Access Compliance Report

Public Rights-of-Way

(Curb Ramps)

Intersection ID: 13787	Main Street: CHARLOTTETOWNE_AV	Cross Street: E_4TH_ST	Location: W
ADA ID: C8B5BC46B78C	Ramp Type: Perp	Initial Pass/Fail: Fail	Overall Compliance: No
Severity Score: 22.5			
Codes/Mitigation Info/Possible Solution		Field Measurements/Component Compliance

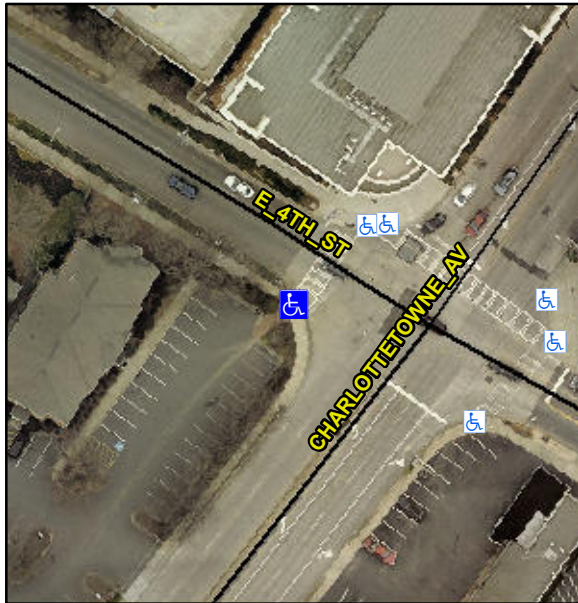
Not Found, R304.5.1, R304.2.2, R304.5.3

Compliance	Description	Data	Compliance	Description	Data
N/A	Ramp Length (in)	91.0	No	Ramp Slope (%)	9.0
No	Ramp Width (in)	47.0	No	Ramp XSlope (%)	3.2
N/A	Flare Type LT	N/A	N/A	Flare Type RT	N/A
N/A	Flare Slope LT (%)	N/A	N/A	Flare Slope RT (%)	N/A
N/A	Flare Traversable LT?	N/A	N/A	Flare Traversable RT?	N/A
N/A	Landing Length (in)	N/A	N/A	DWS Provided?	N/A
N/A	Landing Width (in)	N/A	N/A	DWS Contrast?	N/A
N/A	Landing Slope (%)	N/A	N/A	DWS Length (in)	N/A
N/A	Landing X Slope (%)	N/A	N/A	DWS Full Width?	N/A
N/A	Landing Curb? (Y/N)	N/A	N/A	DWS Offset (in)	N/A
N/A	Shared Landing?	N/A			
N/A	Gutter Ponding?	N/A	N/A	Gutter Slope (%)	N/A
N/A	Gutter Lip Ht (in)	N/A	N/A	Gutter X Slope (%)	N/A
N/A	Painted X Walk1?	Yes	N/A	Painted X Walk2?	N/A
	X Walk 1 Direction	To NE		X Walk 2 Direction	N/A
N/A	X Walk 1 Width (in)	100.0	N/A	X Walk 2 Width (in)	N/A
	X Walk 1 Slope (%)	0.2		X Walk 2 Slope (%)	N/A
	X Walk 1 X Slope (%)	2.6		X Walk 2 X Slope (%)	N/A

Remove & Replace Entire Ramp.
